ADDENDUM NUMBER ONE (1)
CATAWBA COUNTY
BLACKBURN RESOURCE RECOVERY FACILITY OPERATOR'S BUILDING
PROJECT NO. 26.00701

This Addendum Number One (1) is issued this the 14th day of October 2026, to all parties who hold a set of Bid Documents for the project entitled: **“BLACKBURN RESOURCE RECOVERY FACILITY OPERATOR'S BUILDING”**. This Addendum Number One (1) shall become part of the Contract Documents and its receipt acknowledged on the bid documents at the time of bidding.

A301

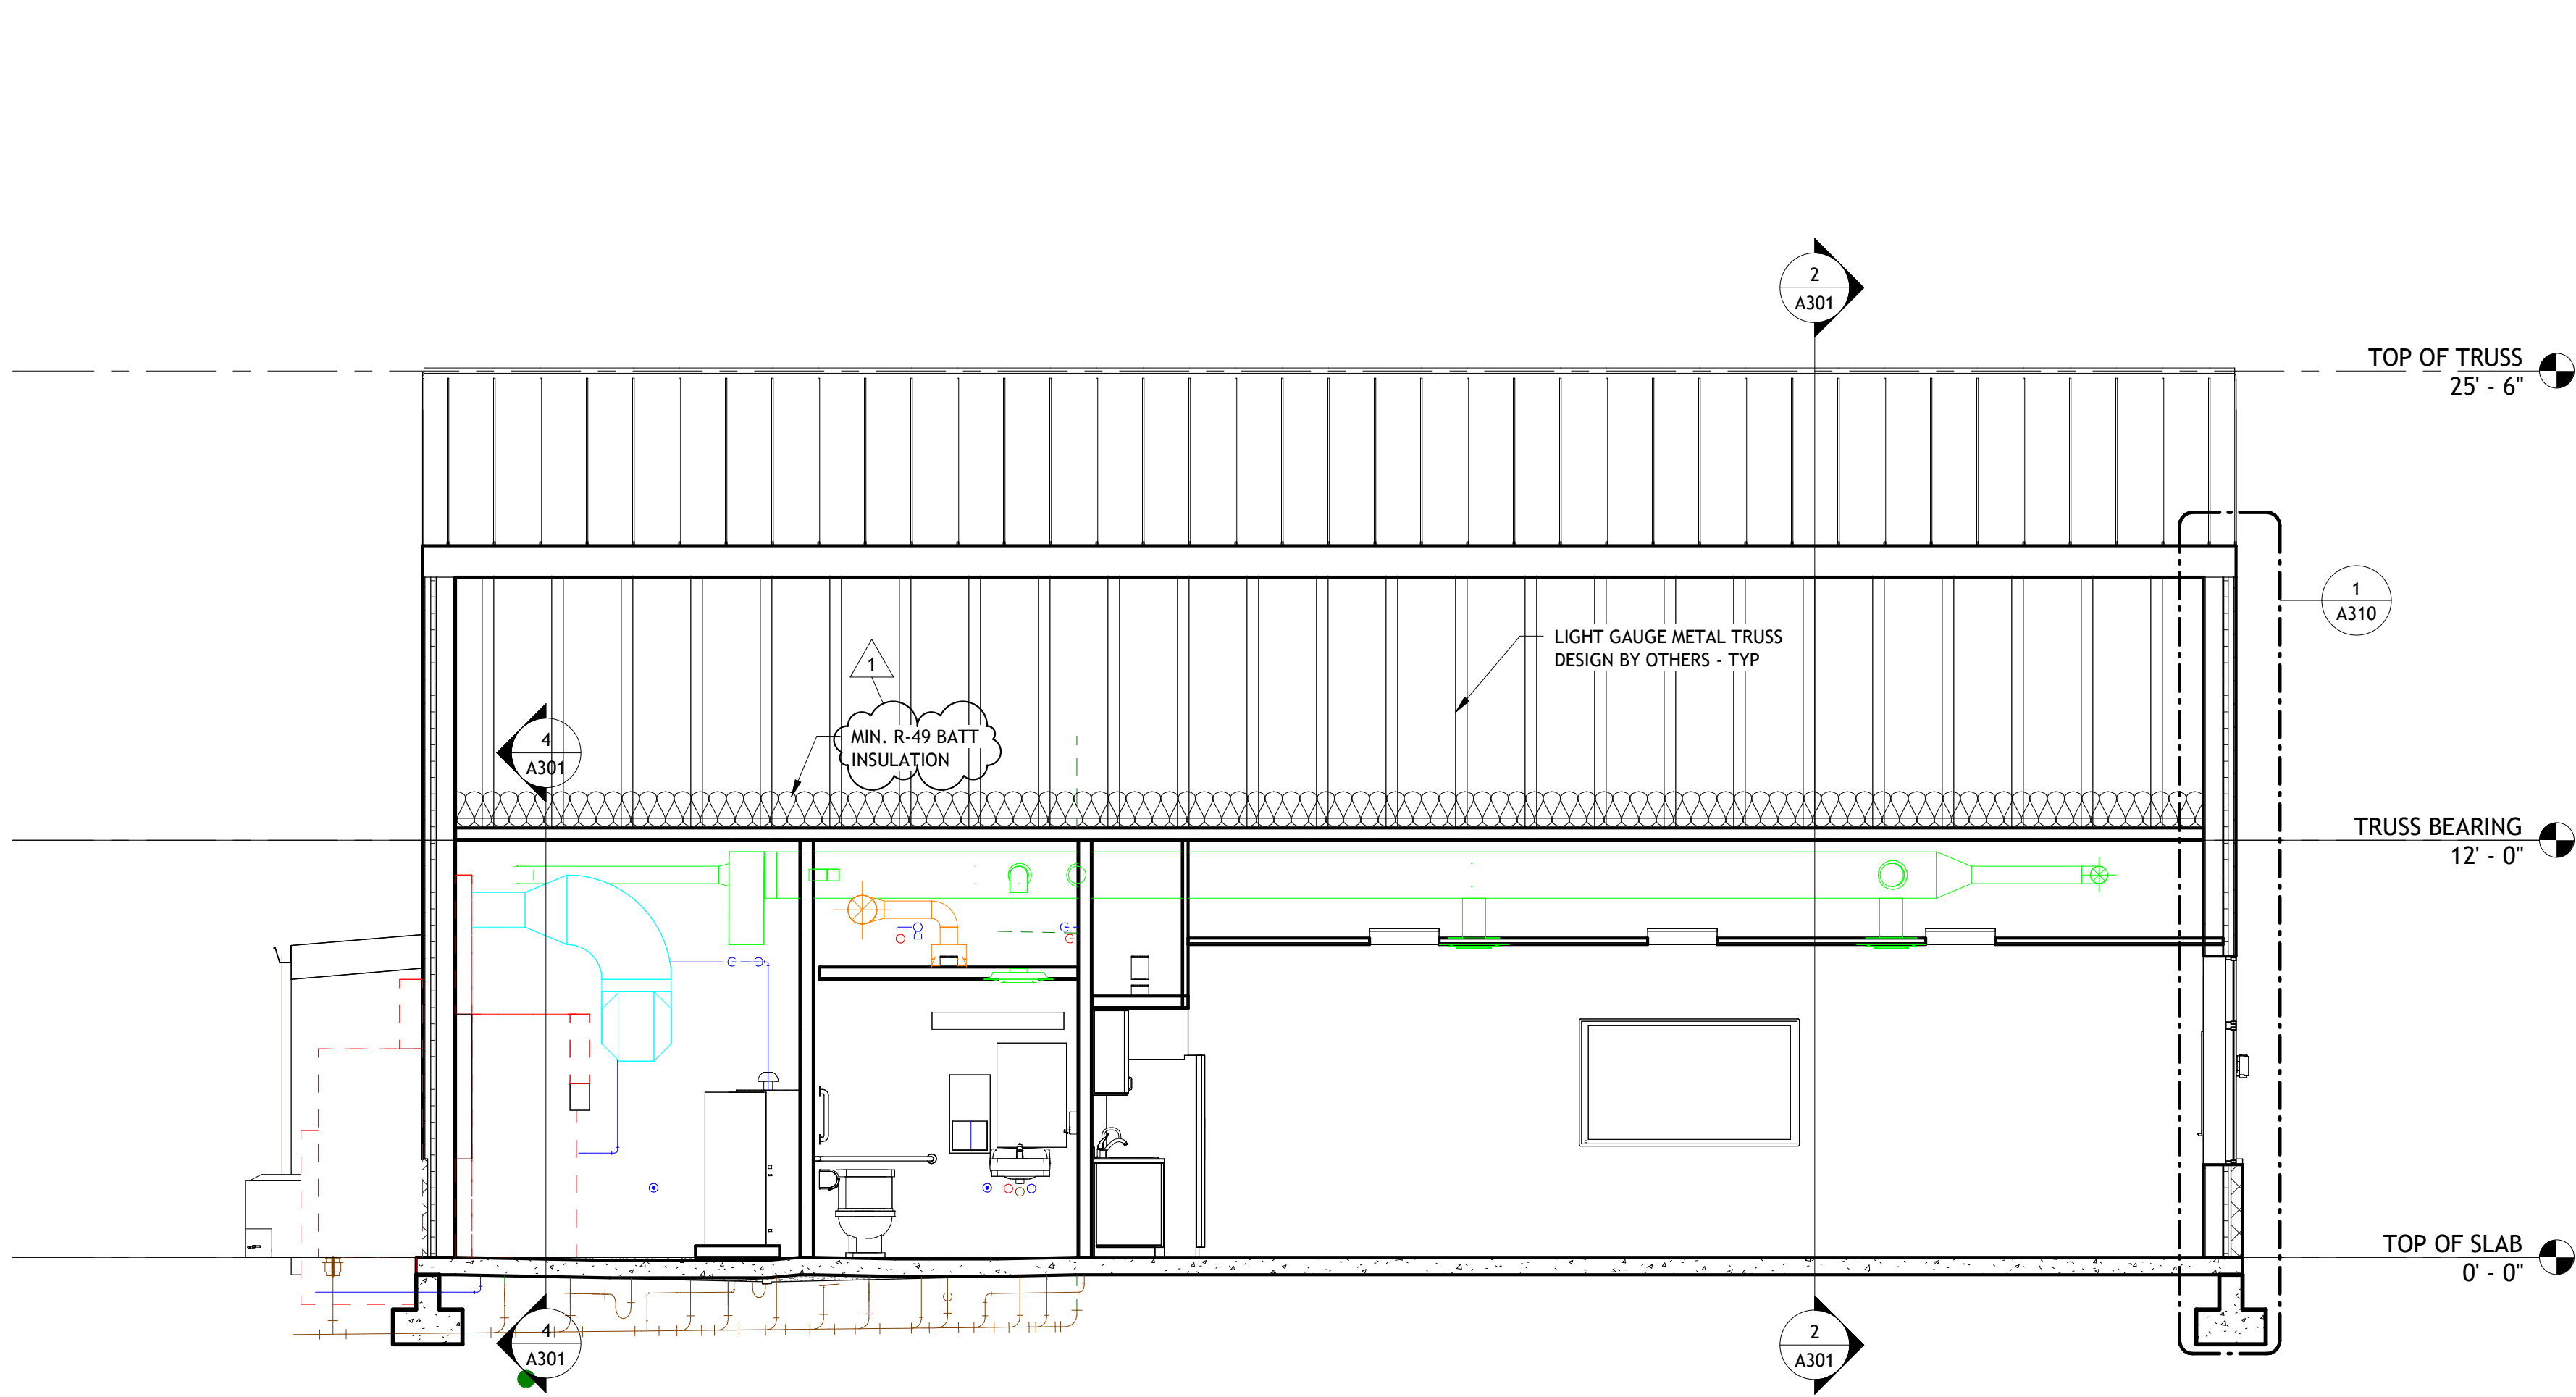
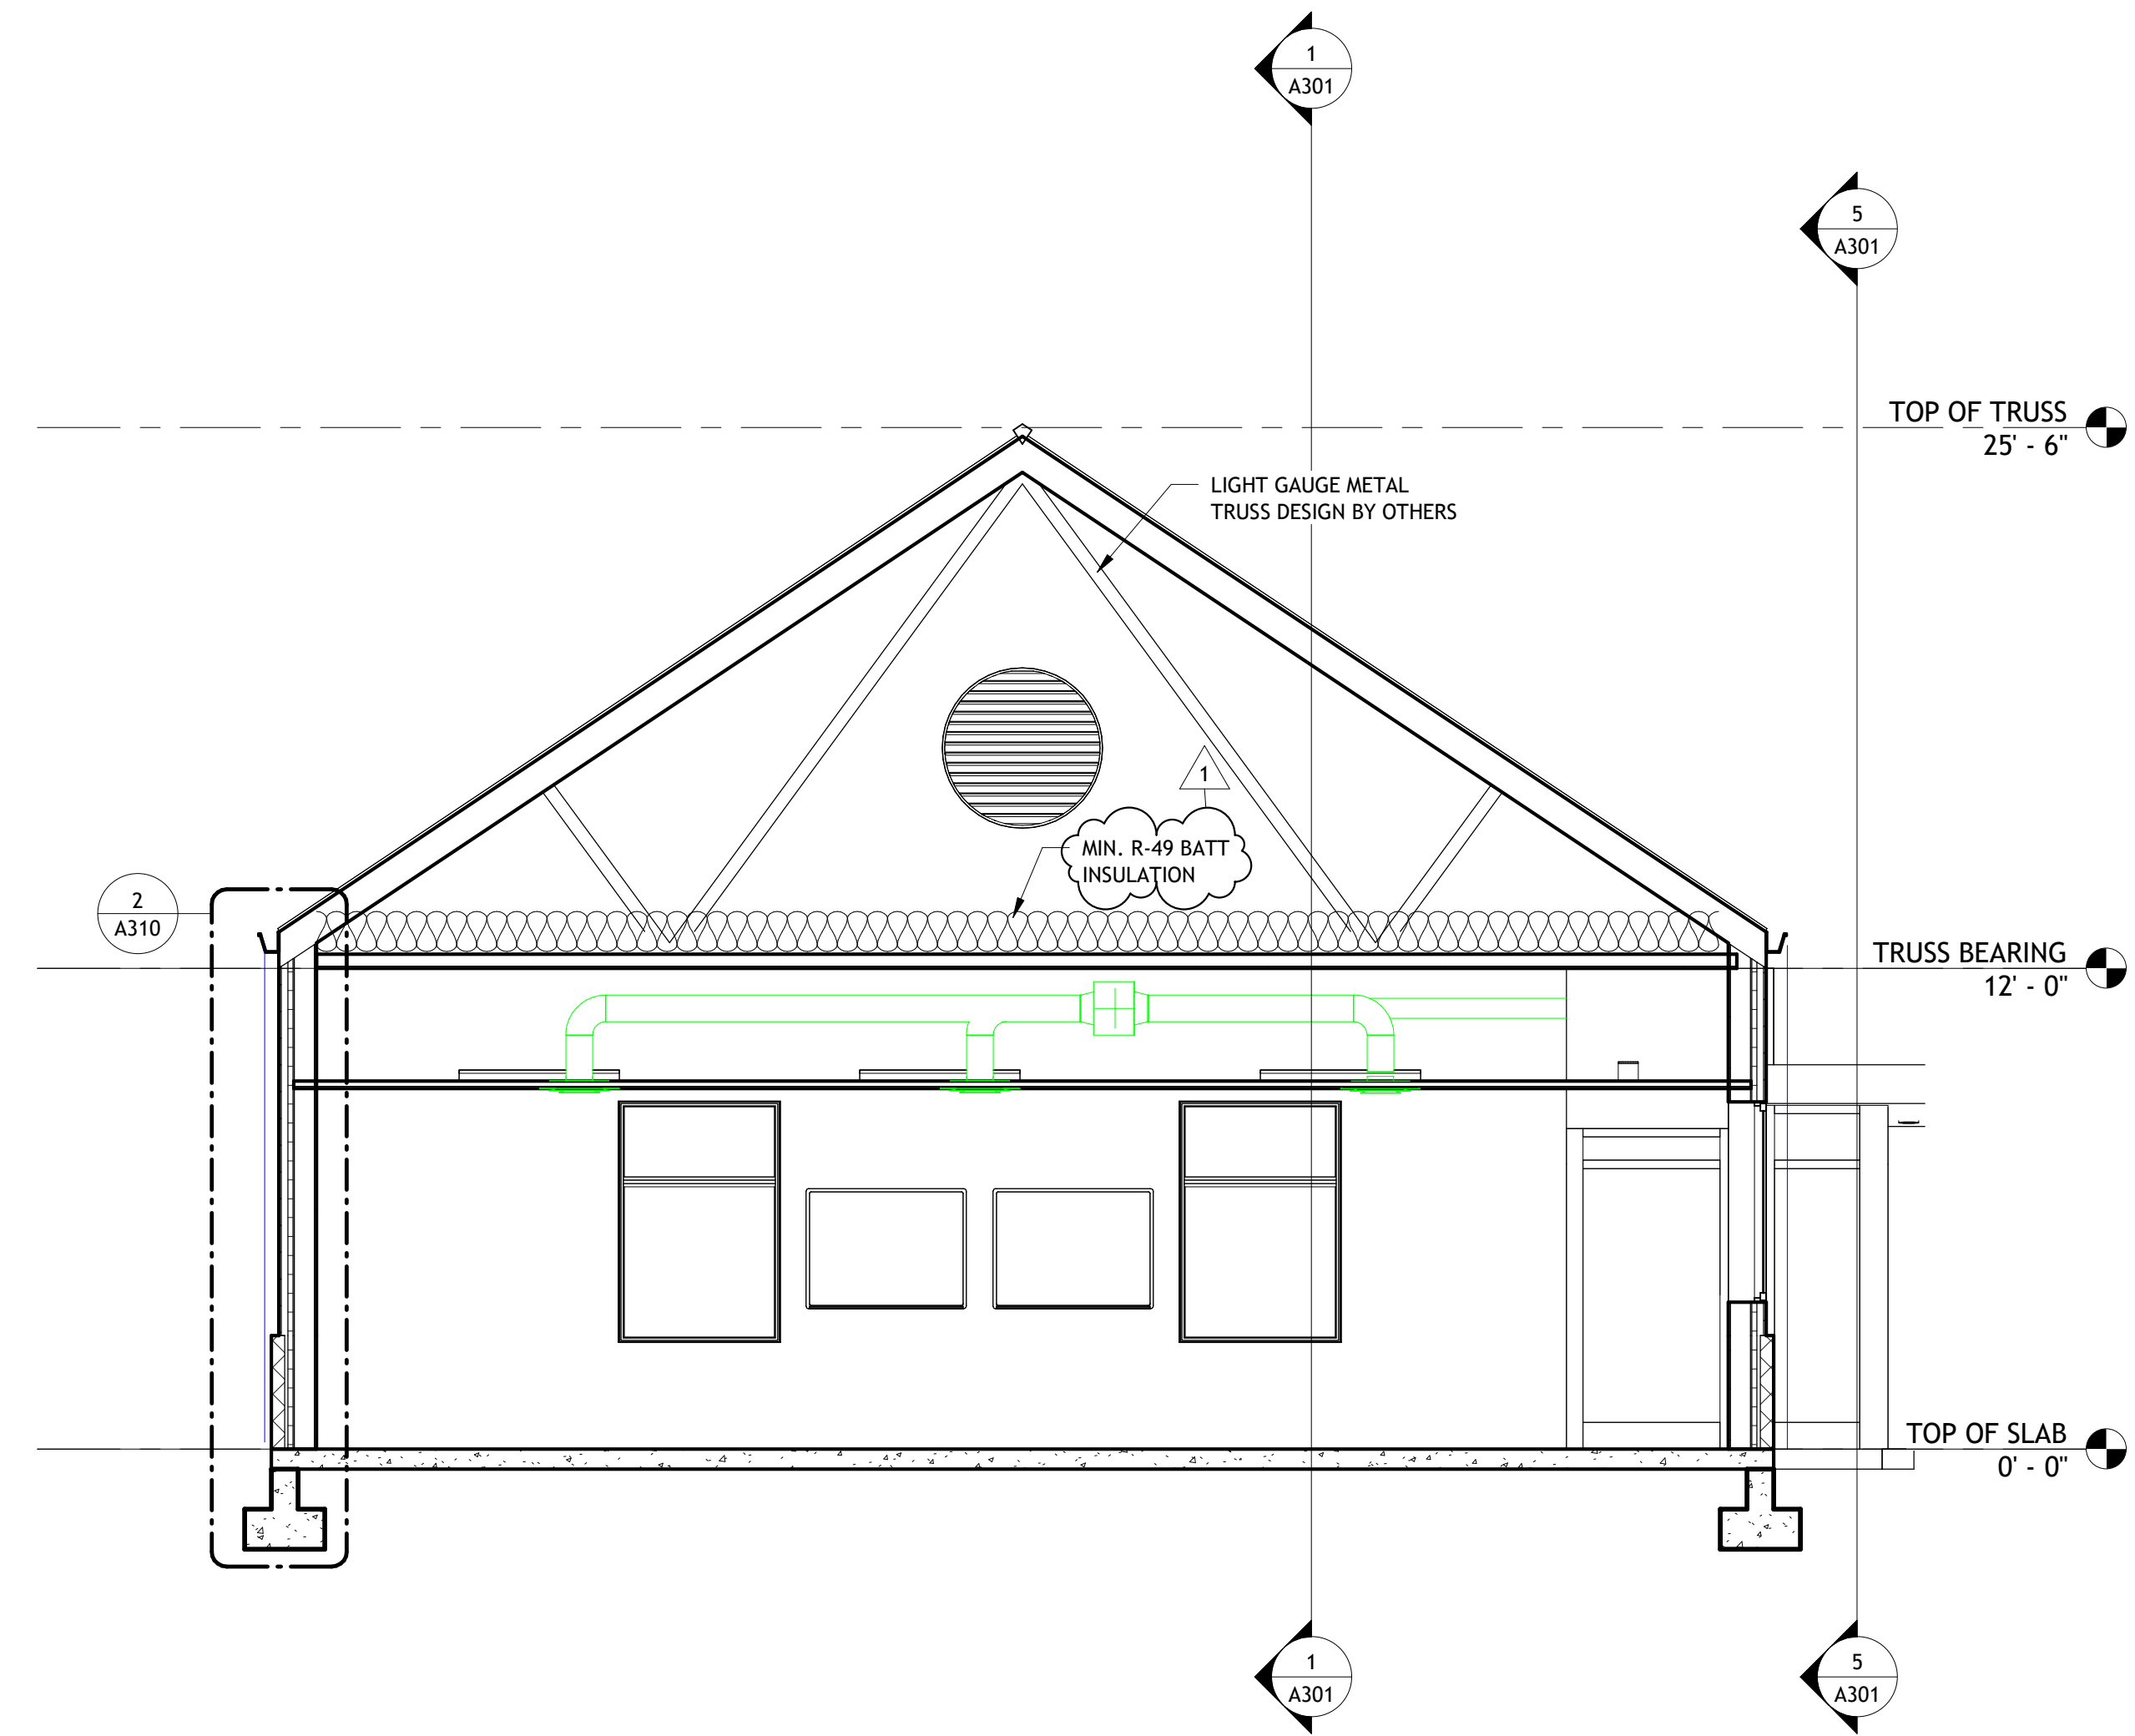
1. Drawings: The below information includes changes, revisions, and updates to the drawings from the original bid set. Please replace the following sheets.
 - a. *Sheet A110*: Revisions made to gutter system and attic insulation types.
 - b. *Sheet A201*: Revisions to gutter system.
 - c. *Sheet A301*: Revisions made to attic insulation type.
 - d. *Sheet A310*: Revisions to gutter system and inclusion of ice and water shield.

- *Will the insulation be blown cellulose or batt insulation in the attic?*

Attic insulation to be batt. Please see revised sheets A110 & A301 in Addendum No. 1.
